**Forum for the Implementation of Reliability  
Standards for Transmission (i2X FIRST) | 10/21/25**

# Challenges with IEEE2800-2022, Planned Revisions – Agenda

# Potential Areas and Issues to Consider During Revision of IEEE 2800

# Reactive Power Capability Requirements (Clause 5.1)

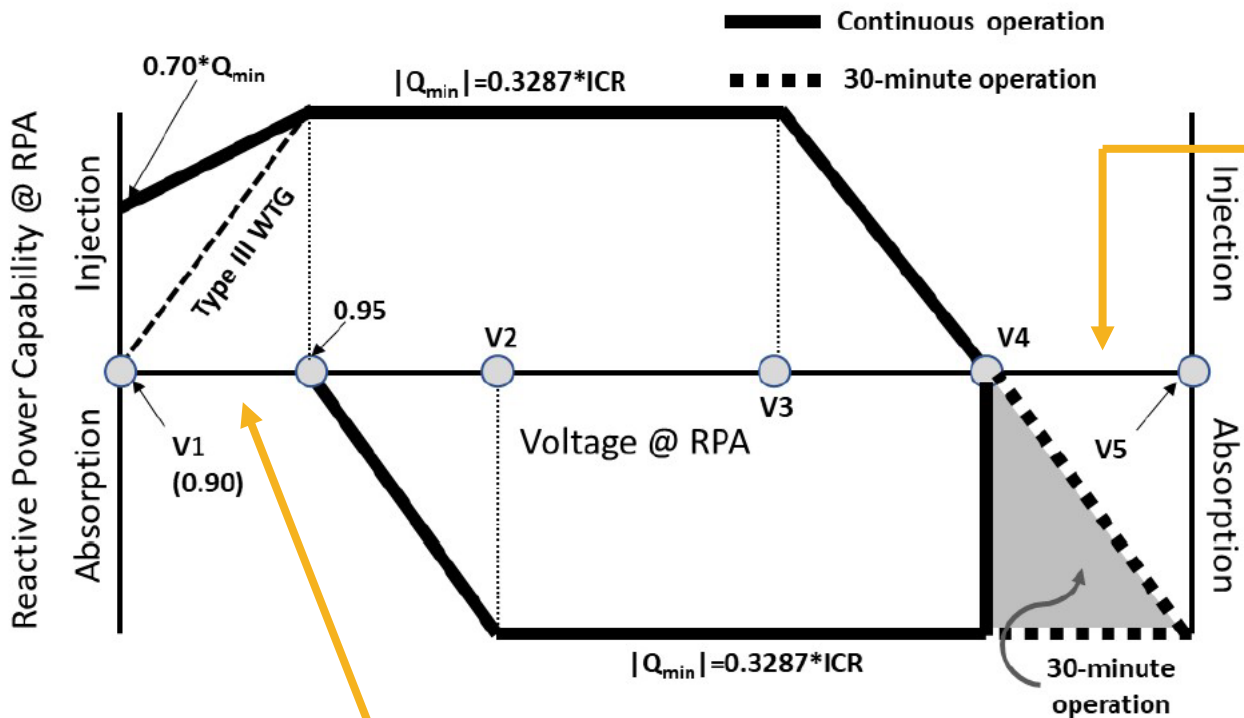
Not sure why this requirement applies to IBR unit instead of IBR plant.

In case where the requirement applies at the POM, all IBR units in the plant do not need to have capability to operate at zero active power to conform to reactive power capability requirement.

# Voltage Control (Clause 5.2.2)

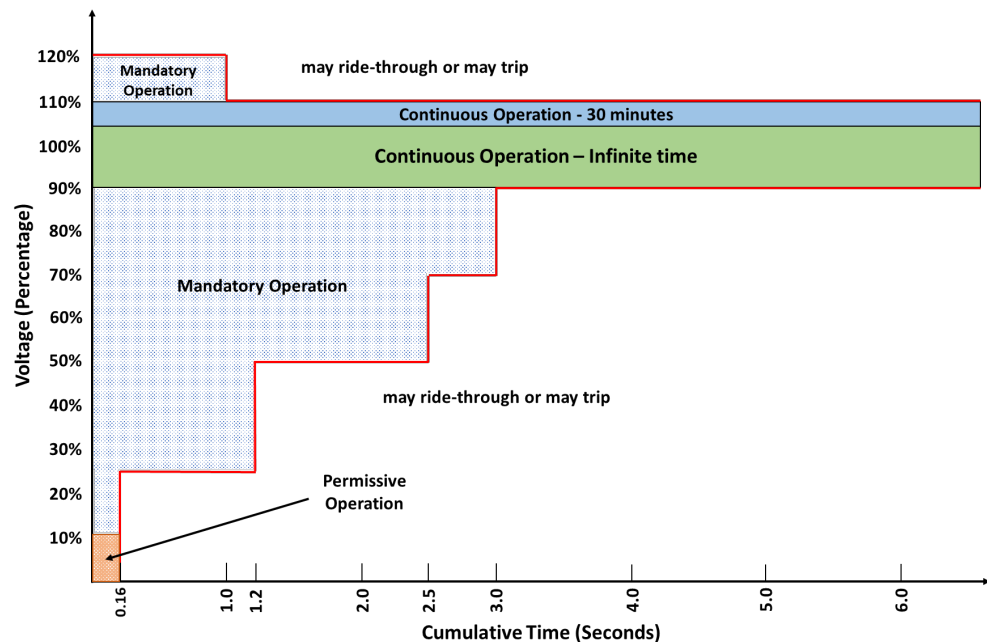
Need clarification if measurement time is included or not in reaction time requirement. Included or not, what should be a reasonable reaction time?

# Voltage Ride-Through Capability Requirements (Clause 7.2.2.1)

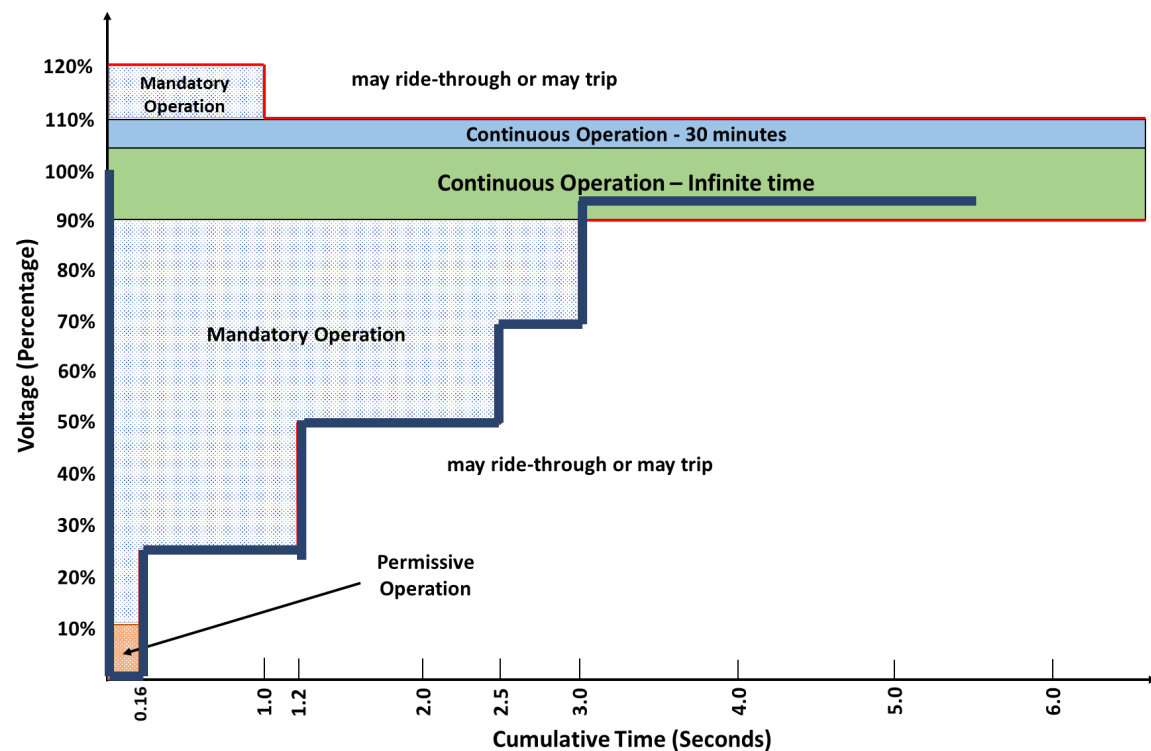
The Standard states “*IBR plant shall ride through a voltage disturbance event wherein the applicable voltage exceeds or is less than the voltage range representing the continuous operation region, except for voltage magnitude deviations more severe than the voltage thresholds and persisting for greater than the associated durations as specified.*”

Based on this understanding, one interpretation of the voltage ride-through requirement is that a wind plant must withstand a **single** voltage disturbance event where the voltage drops to zero at time  $t = 0$ , then gradually recovers as follows:

- Rises to 0.25 pu at  $t = 0.16$  s
- Rises to 0.5 pu at  $t = 1.2$  s
- Rises to 0.7 pu at  $t = 2.5$  s
- Rises to  $> 0.9$  pu at  $t = 3$  s

# Consecutive Volt Deviation RT Capability Req (Clause 7.2.2.4)

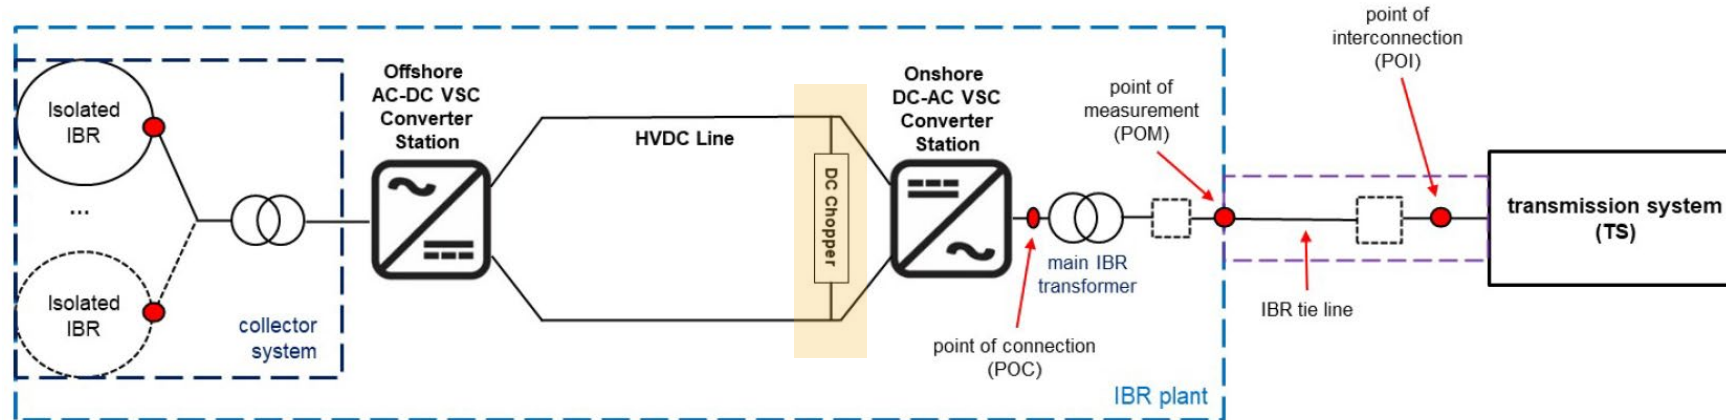
Requirements are too complicated, and it is impractical to test many different scenarios.

# Consecutive Volt Deviation RT Capability Req (Clause 7.2.2.4)

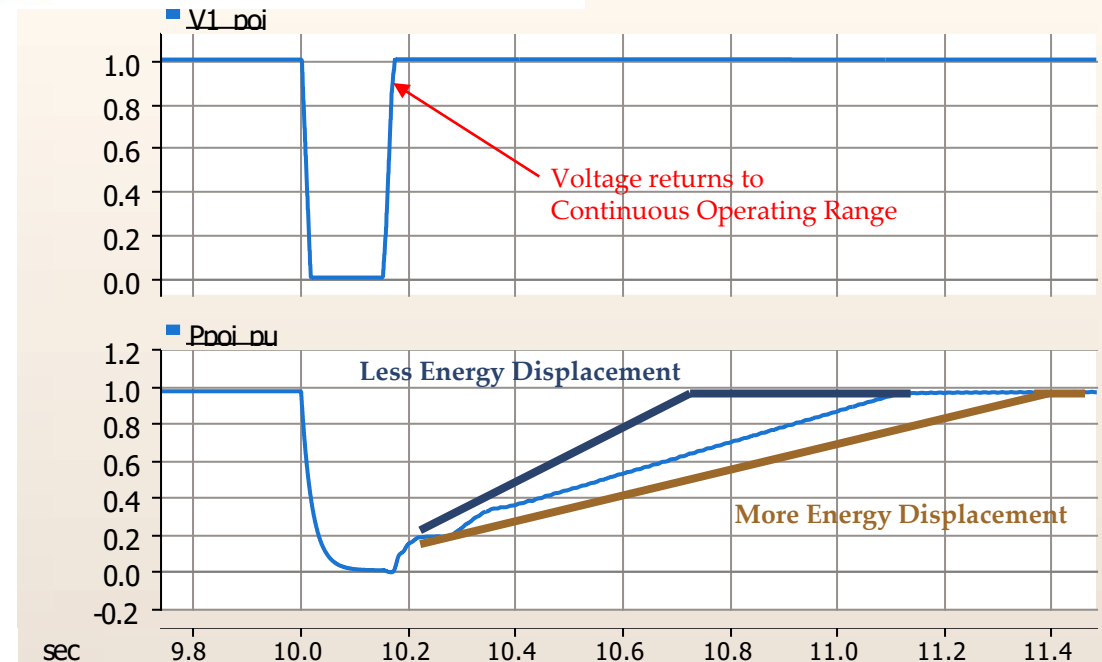
Challenging for VSC-HVDC (used with offshore wind plants) and certain type IV WTGs.

Ability to conform to voltage ride-through requirements (including consecutive VRT) depends on: balance of active/reactive current during a fault + post-fault active power recovery time
